Sent: 24/05/2020 4:56:51 PM
Subject: Objection Letter DA2020/0434 62 Mactier St Narrabeen
Attachments: 200524 Objection Letter DA2020_0434_North Beaches Council re 62 Mactier st.pdf;

RE OBJECTION SUBMISSION DA2020/0434, 62 MACTIER ST NARRABEEN

Previous DA Submission DA2019/0975 North Elevation below:

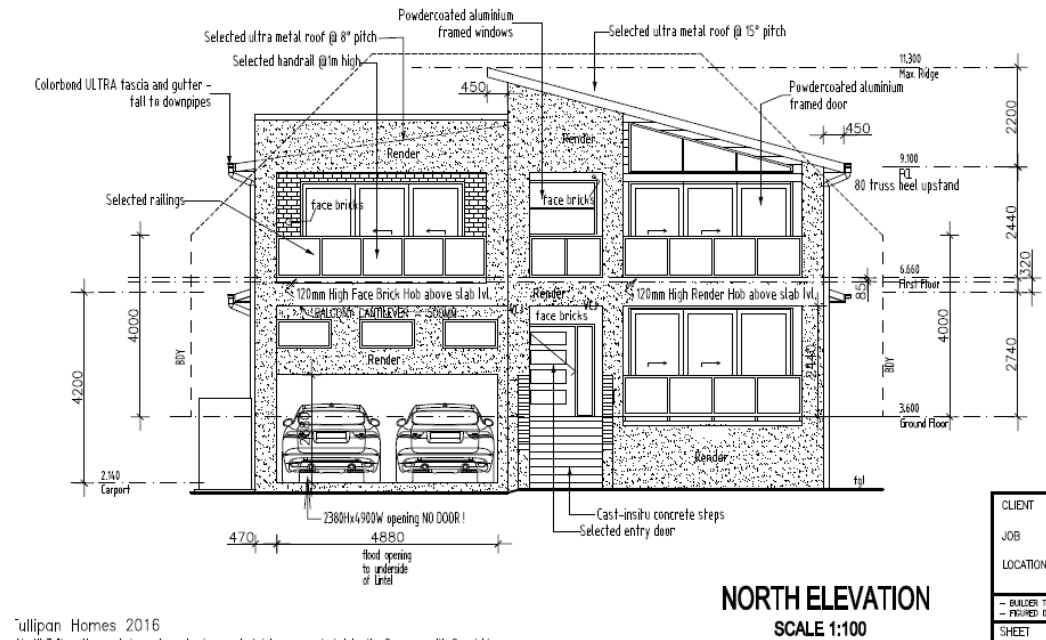
The side envelope incorrectly control started from increased floor level and still breached the envelope.

Excerpt from Current DA2020/0434 below:

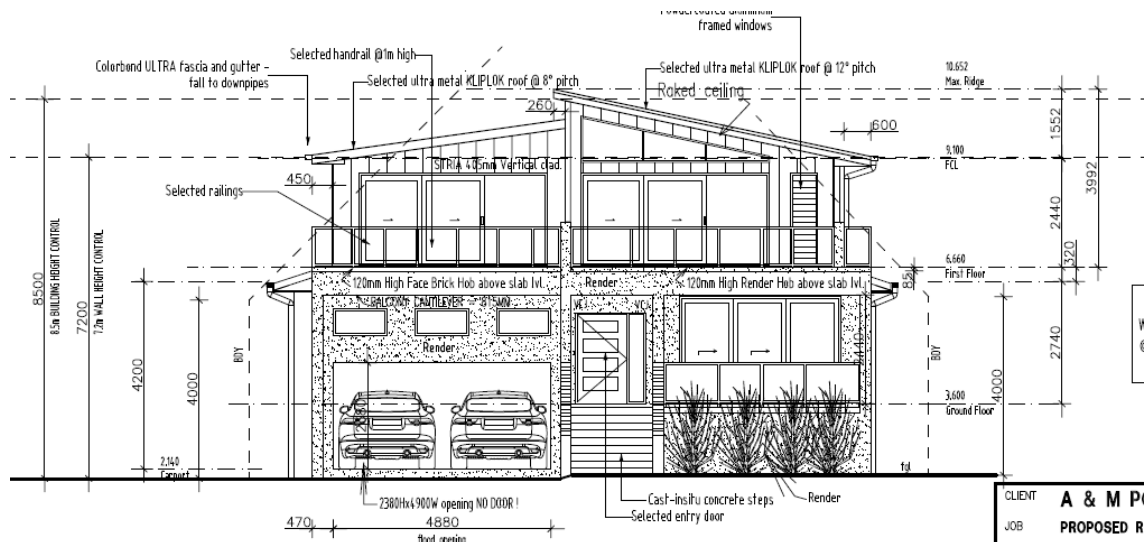
Shows the similar level of envelope non-compliance but at least the envelope control commences from the ground level currently being considered in the cl4.6.

We realise that the upper floor plan needs to be functional. We would accept the reduction in the second floor width by 500mm which would still render the envelope non-compliant but acceptable compromise to us.

Excerpt from DA2019/0975 sheet 1 of 15:

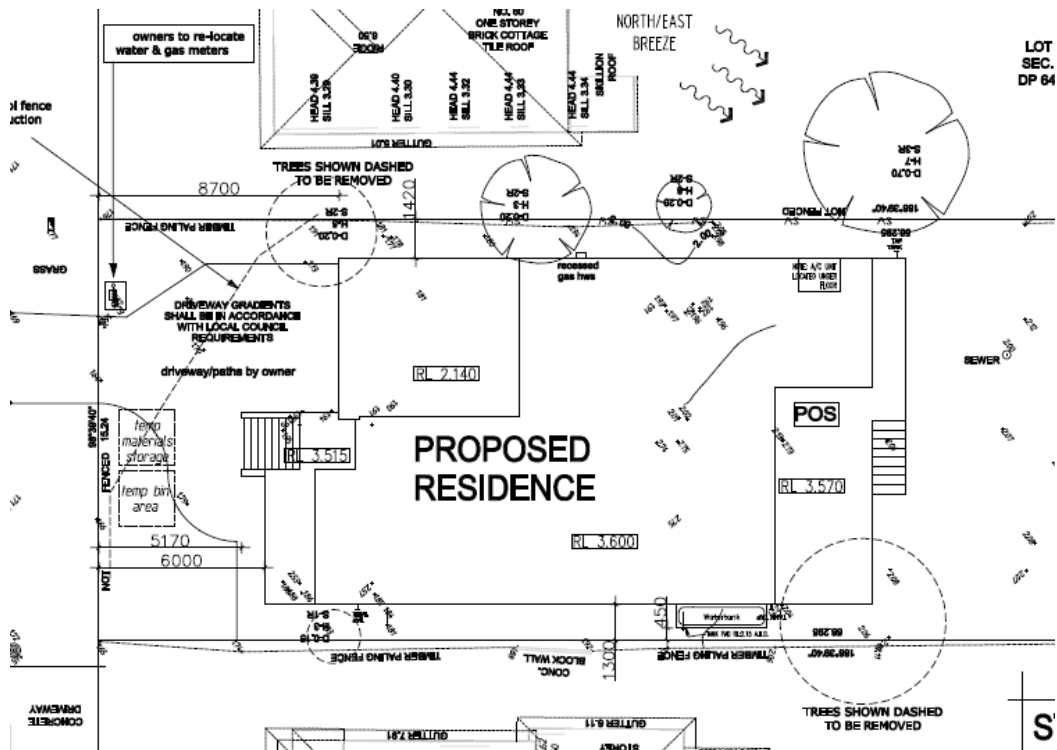
The Previous DA2019/0975 the site set back was 1.4 and now it is 1m and we note the building width has grown from 15.520m to 15.94m. We do acknowledge that the minimum side set back is 1m but request for the east side setback be minimum 1.2m which will assist in reducing the solar shadowing which is substantial in winter equinox:

We objected to the location of the air conditioning condensers being located in the corner of the house in the previous submission DA2019/0975. See excerpt above on the eastern boundary.
